MAINE TURNPIKE AUTHORITY

ADDENDUM NO. 3

CONTRACT 2022.07

INTERCHANGE IMPROVEMENTS

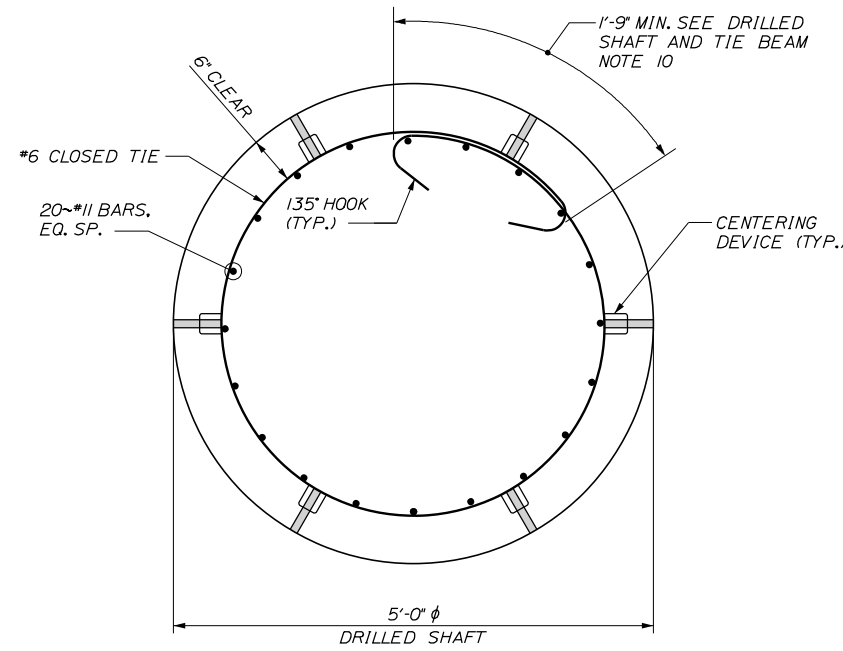
16. Please provide a drawing for the wiring in the existing 3" conduit shown on Sheet 261.

Answer: This conduit was installed under Contract 2022.02. The plans for this project are available on the MTA website.

SHEET NUMBER: SS-38
CONTRACT: 2022.07
243 OF 735

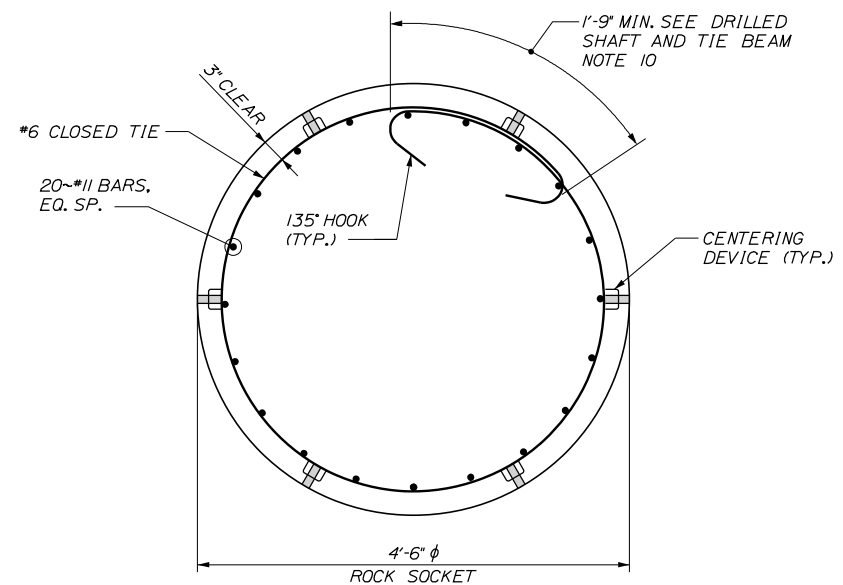
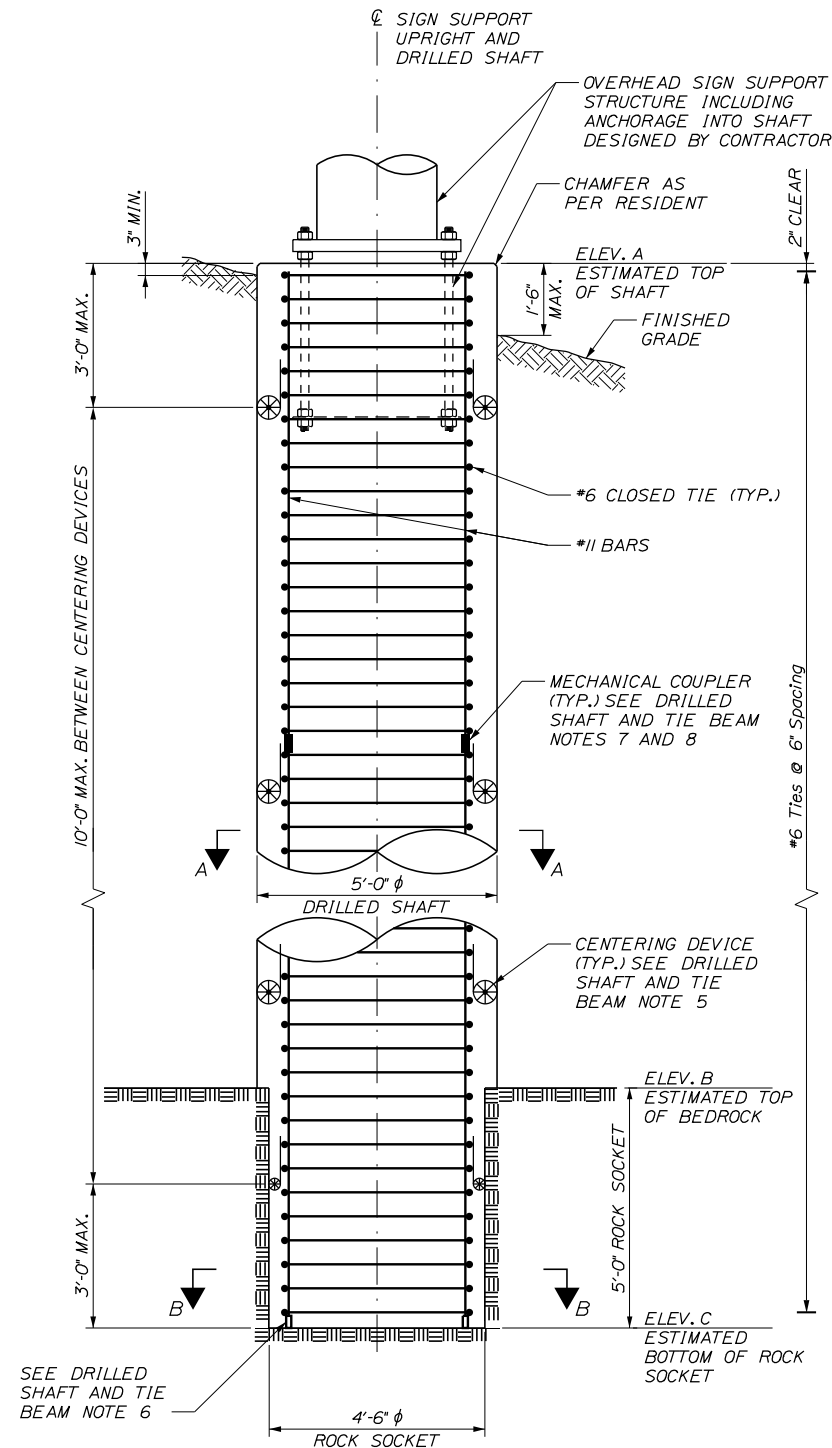
- Plan Sheet 243 of 735, OVERHEAD SIGN FOUNDATION DETAILS (2 OF 3), has been deleted in its entirety and replaced with Plan Sheet 243 of 735, included in this addendum.
- Plan Sheet 599 of 735, I-195 UNDERPASS SOIL NAIL WALL DETAILS, has been deleted in its entirety and replaced with Plan Sheet 599 of 735, included in this addendum.
- Plans Sheet 645 of 735, ELECTRICAL & MECHANICAL BOOTH DETAILS, has been deleted in its entirety and replaced with Plan Sheet 645 of 735, included in this addendum.

14. Please confirm that all Overhead Sign Foundations will be paid under the appropriate #645 Overhead Sign Bid Items and not under #626 Bid Items?

Answer: Yes, overhead sign structure foundations are paid under the appropriate 645.15 items. Note #2 on sheet 243 has been revised to say structures instead of bridges in Addendum No. 3.

1. ALL FOUNDATIONS SHALL BE CONSTRUCTED AS SHOWN ON THESE PLANS AND IN ACCORDANCE WITH SPECIAL PROVISION 645.
2. OVERHEAD SIGN BRIDGES AND THEIR FOUNDATIONS SHALL BE PAID UNDER THE APPROPRIATE 645.12 ITEMS. OVERHEAD CANTILEVER SIGN SUPPORT STRUCTURES AND THEIR FOUNDATIONS SHALL BE PAID UNDER THE APPROPRIATE 645.15 ITEMS.

Scale: AS NOTED			
No.	Revision	By	Date
1	REVISED NOTE	JRH	11/22

**EXISTING I-195 BRIDGE
WEST ABUTMENT LOADS**
SCALE: NTS

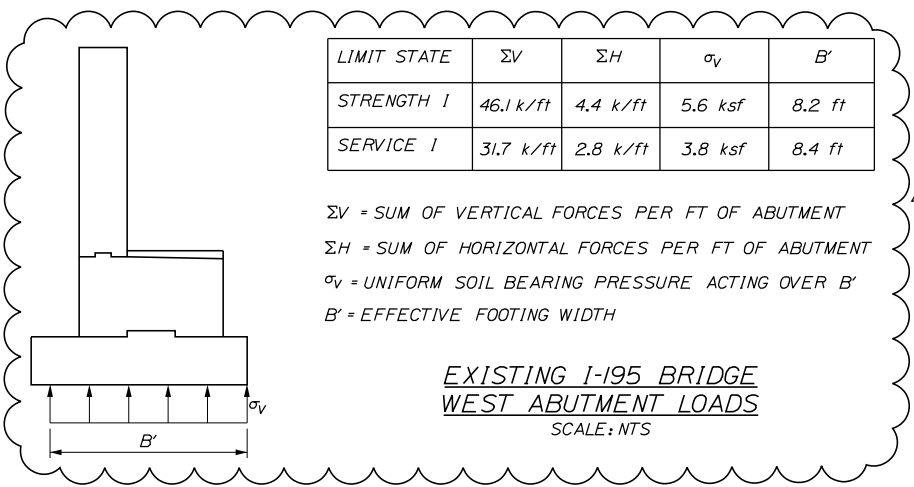
12. Question: What are the anticipated factored and unfactored vertical and horizontal loads applied to the abutment for the design of the soil nail wall?

Answer: Factored (Strength I) and unfactored (Service I) loads are provided on updated sheet 599 SN-03 in Addendum No. 3.

LIMIT STATE	ΣV	ΣH	σ_v	B'
STRENGTH I	46.1 k/ft	4.4 k/ft	5.6 ksf	8.2 ft
SERVICE I	31.7 k/ft	2.8 k/ft	3.8 ksf	8.4 ft

No.	Revision	By	Date
1	ADDED ABUTMENT LOADS	PAG	11/22
